# Heathcote Road bridge widening

Submissions report

Transport for NSW | June 2021

Figure 2-2 Summary of crash statistics for Heathcote Road bridge and its approaches

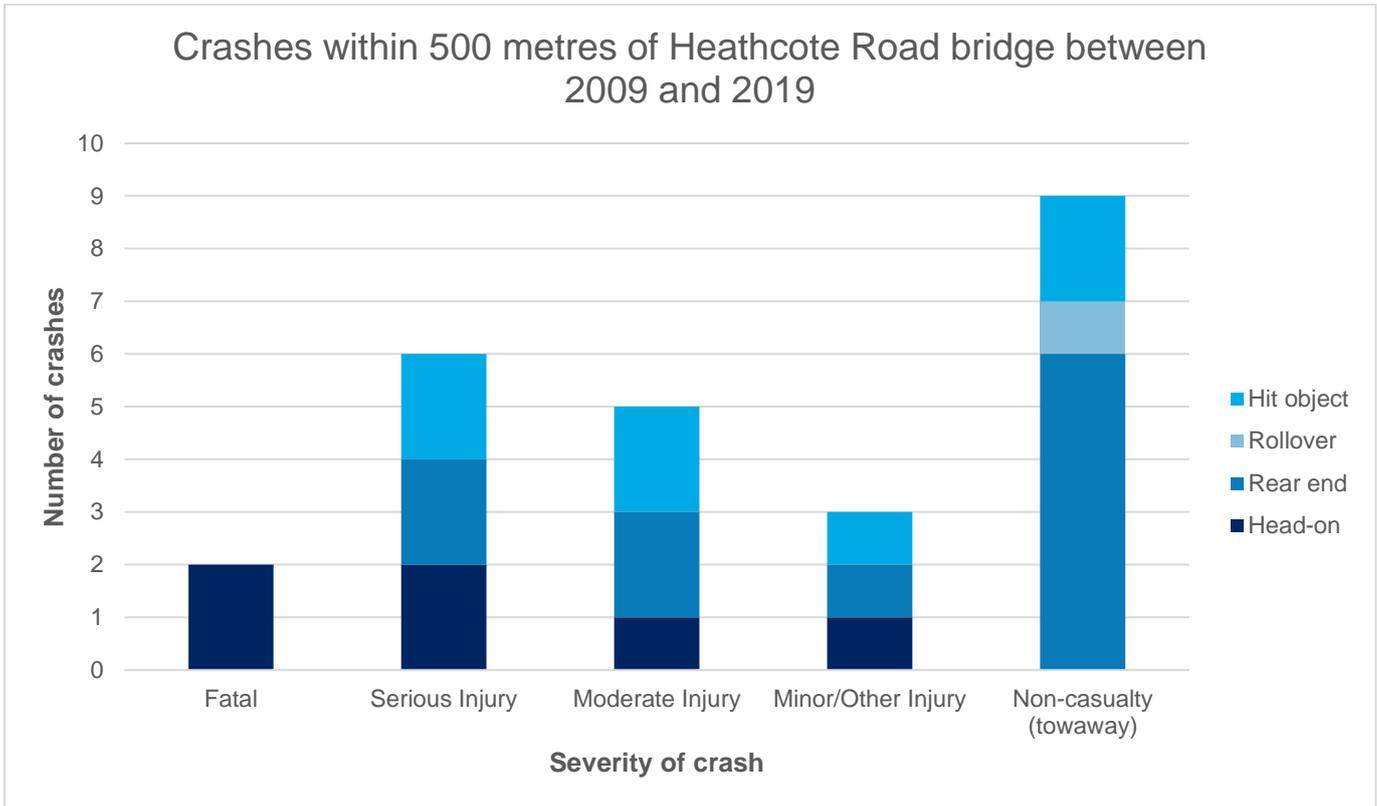
- concerns that the current design is a 'quick fix' that would not be suitable in the future due to traffic growth and planned development within the Sutherland Shire
- concerns that the bridge widening alone would not be able to improve safety and decrease risk of crashes
- opinions that a new bridge parallel to the existing bridge or additional lanes on the Heathcote Road bridge are required to address the existing safety and traffic flow issues experienced
- requests for a commitment for a future 'longer term' upgrade that would involve a bridge duplication and/or additional lanes.

The need to improve road safety in the short-term along the Heathcote Road bridge and its approaches is evidenced by:

- the results of the consultation carried out by Transport for NSW in May and June 2020, which identified that over 80 per cent of people were concerned about the safety of the Heathcote Road bridge
- recent road incidents that have occurred on the Heathcote Road bridge and its approaches, including fatalities and serious injuries (refer to Figure 2-2)
- the urban casualty crash rate for the A6 section of Heathcote Road (1.77 casualties per kilometre per year), which is about 2.14 times higher than the typical rate for the same road type
- the commitment made by the Minister for Roads, Maritime and Freight in 2018 to improve the safety of the Heathcote Road bridge.

Figure 2-3 Recently completed or planned projects along Heathcote Road (Transport for NSW, 2020c)

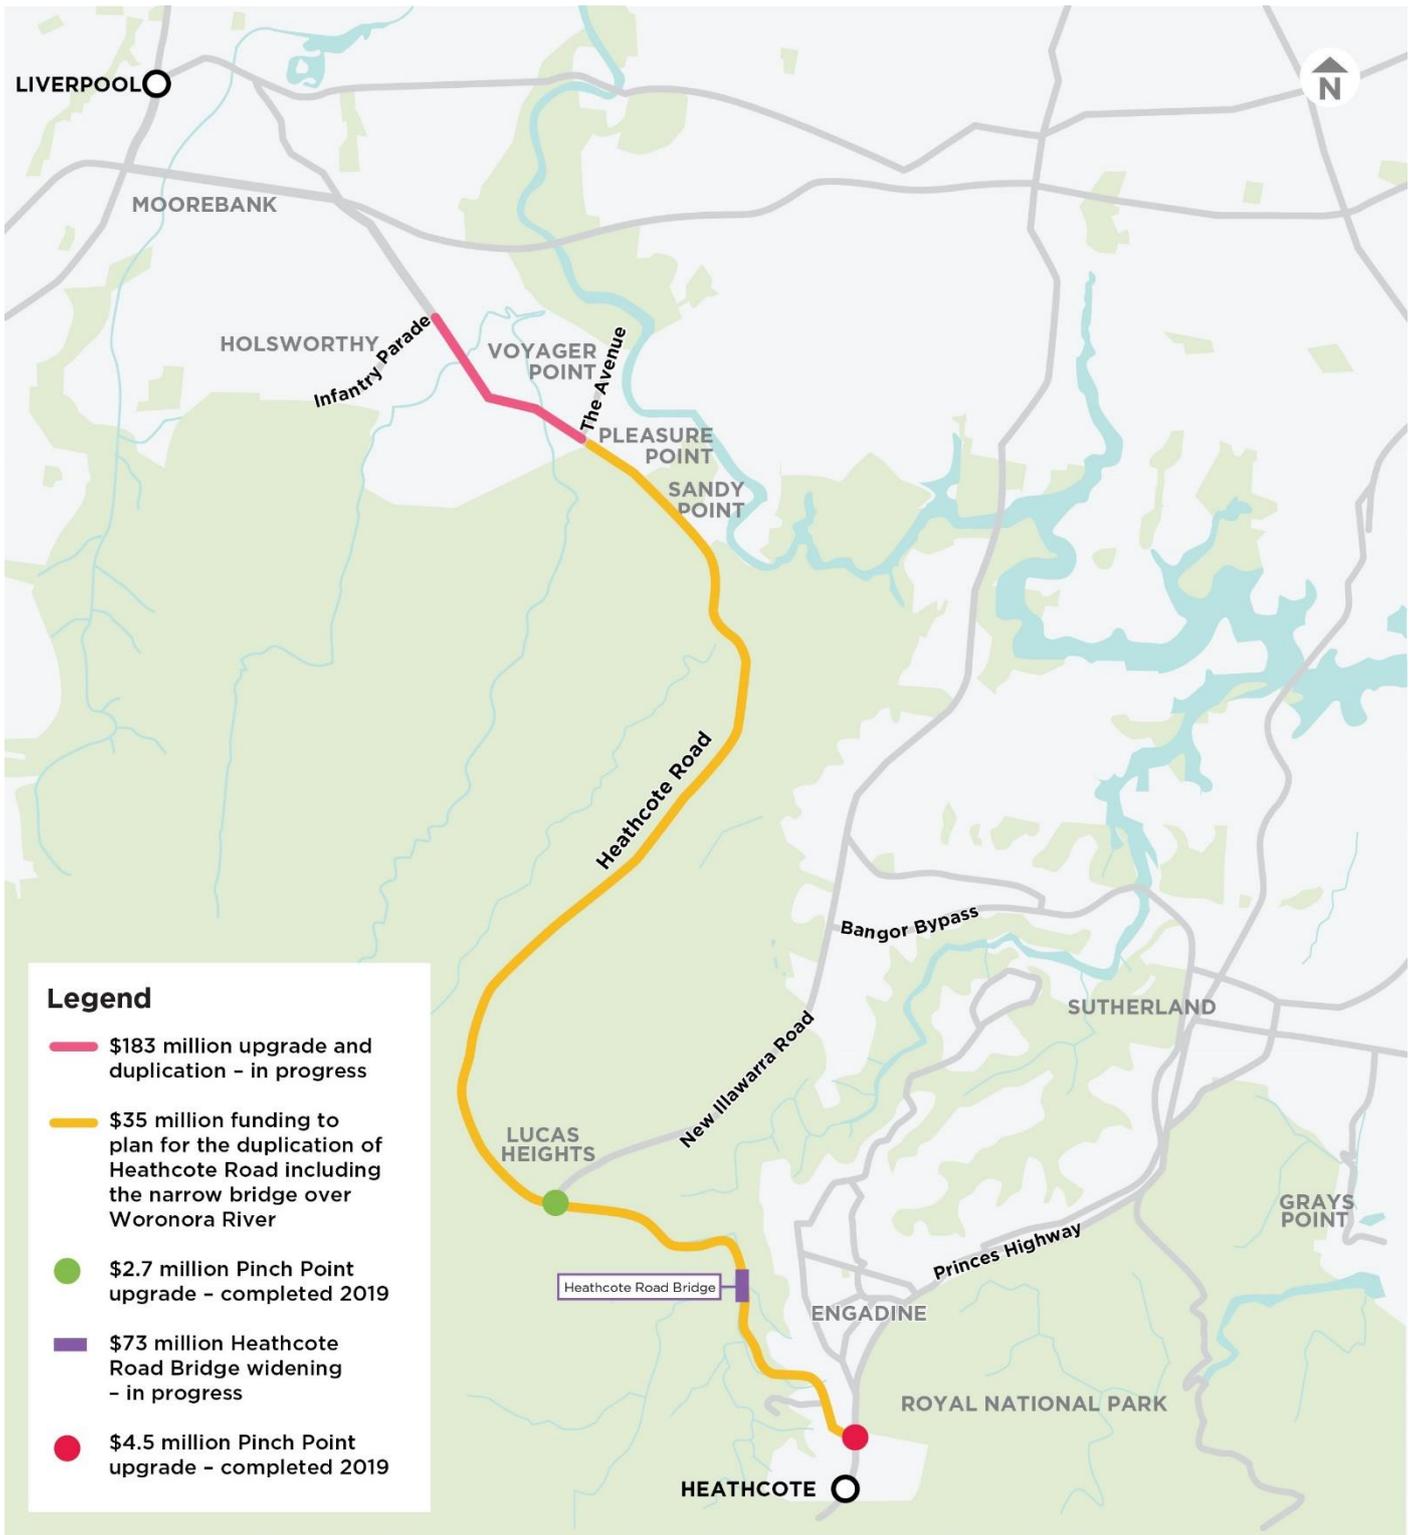
- suggestions to review opportunities to provide additional measures for fauna connectivity (particularly focusing on koalas) at several other locations along the Heathcote Road corridor that have records of fauna roadkill such as the underpasses at Harris Creek, Williams Creek and Deadmans Creek at Sandy Point

- suggestion that providing additional fauna connectivity measures at other locations along Heathcote Road at the same time as the Heathcote Road bridge widening construction would provide value as road closures would already be in place and procurement for equipment could be done at the same time.

Table 2-1 and Figure 2-3 presents a summary of nearby road upgrade projects that are ongoing or have been recently completed by Transport for NSW within the surrounding road corridor, which includes several improvements along Heathcote Road.

Figure 2-5 Overview of the Linden Street Upgrade project (Transport for NSW, 2020)

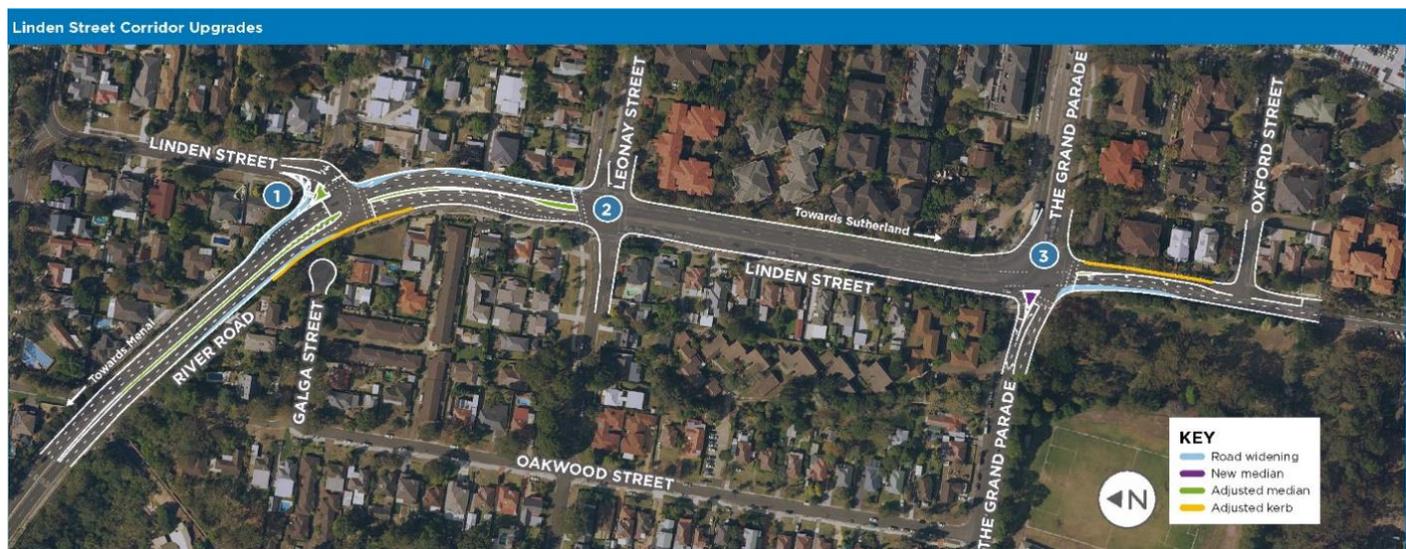
- comment that the Princes Highway Upgrade at Acacia Road has been delayed and may not be completed by the commencement of construction for the proposal
- comment that the Linden Street Upgrade project may not commence before the proposal and does not consider the potential impacts of the road closures as part of the Heathcote Road bridge widening project
- concern that the cumulative traffic delays would be large as the detour route passes through areas that are already under severe traffic stress from other construction projects.

Linden Street upgrade project is in the pre-construction phase, with the main construction phase scheduled to start at the end of 2021 (Transport for NSW, 2021d). The Linden Street Upgrade project would involve work along Linden Street and River Road (refer to Figure 2-5), which are part of the proposed detour route for the Heathcote Road widening project.

Figure 3-1 Frequency of crash types along Heathcote Road bridge and its approaches

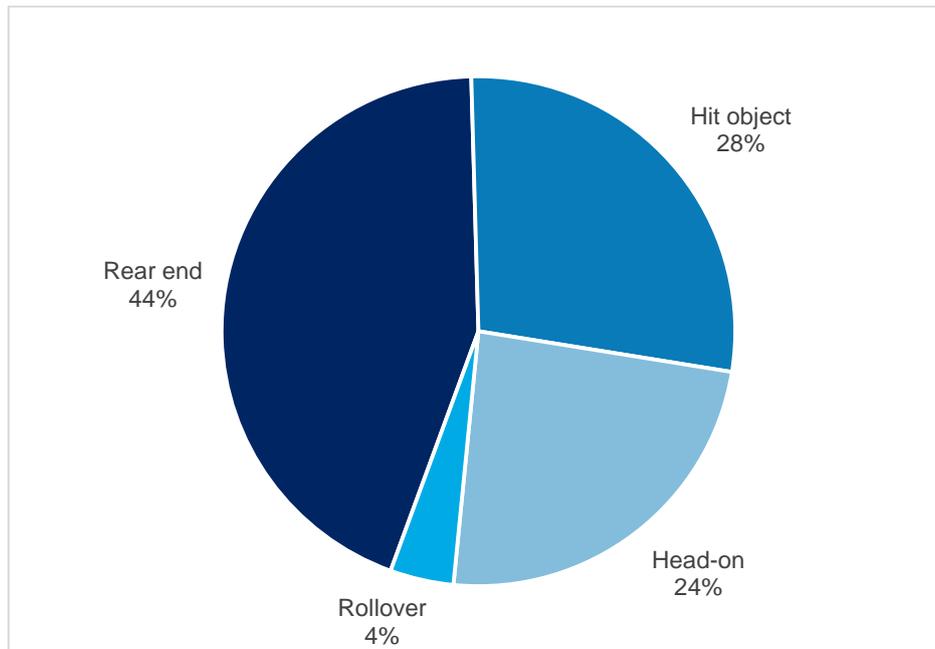
- the proposal does not provide a central median safety barrier to separate the bidirectional travel lanes and therefore does not properly address the most significant safety risks for road users, the risk of head-on collisions with serious injury to fatal consequences

- while the widened bridge will provide some additional clearance between opposing traffic, any mitigation of head-on risk is potentially offset by the likely increase in speed on approach to and across the bridge.

The proposal addresses the key proposal objectives as it provides a design solution that can be implemented in the short term to improve road safety and network reliability. In particular, it would directly address the safety hazard of the narrow lanes and improve the road geometry of the approaches to the bridge to meet current road design standards.

Analysis of crash history statistics within 500 metres of the Heathcote Road bridge between 2009 and 2019 shows that the most common type of crash was rear end collisions (44 per cent of crashes), followed by crashes involving hitting an object (28 per cent of crashes) and head-on collisions (24 per cent of crashes).

Most of the head-on collisions currently observed on the Heathcote Road bridge and its approaches are considered to be a result of the narrow lanes reducing the room for error for vehicles, which can cause vehicles to easily cross into the oncoming lane of traffic. This risk is expected to be minimised through the widening of the Heathcote Road bridge and its approaches. Widening and improving the alignment of the approaches to the bridge is expected to reduce the potential for vehicles to hit objects (e.g. the steep rock cuttings on either side of the road). The potential for rear end collisions is also likely to reduce as vehicles are less likely to need to stop or slow at the approach to the bridge to wait for vehicles to pass, which can cause vehicles to brake hard or stall.
